From: Paul Troop [REDACTED]
Sent: 31 August 2023 15:27
To: Planning; Suzanne Taylor; White, Joy - Oxfordshire County Council
Cc: chair@bicesterbug.org
Subject: 21/04275/OUT Further Comments from Bicester Bike Users' Group

2. INTERIM SCHEME (APPENDIX P, P.356)

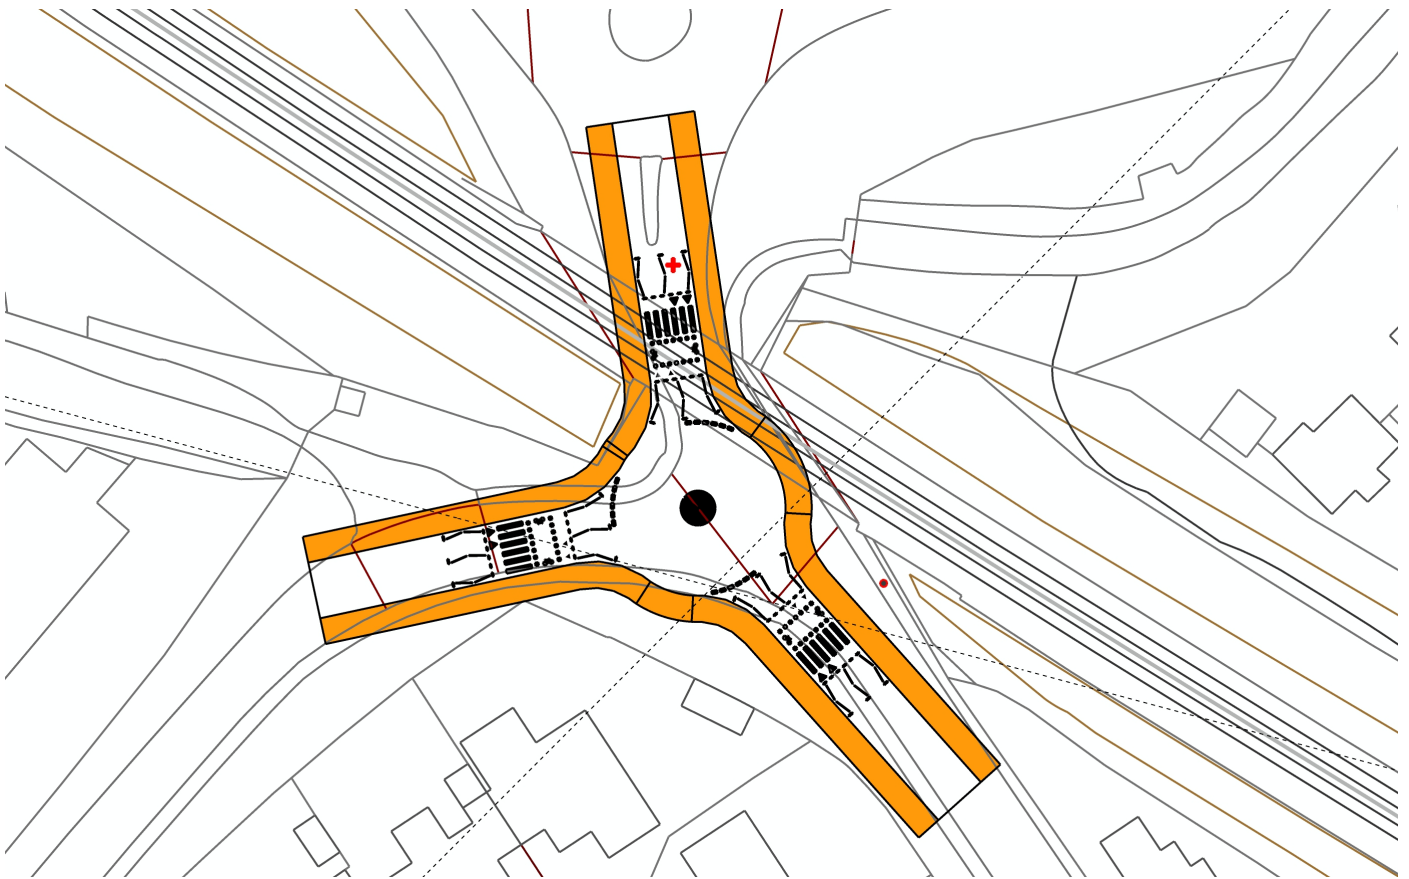
The applicant might explore more imaginative solutions to this junction, for example a 'Dutch' style mini-roundabout with active travel crossings suggested below. This would also have the benefit of being a design that also works longer term and would not need to be revised in the future. Failing this, the application should be refused on highway grounds.
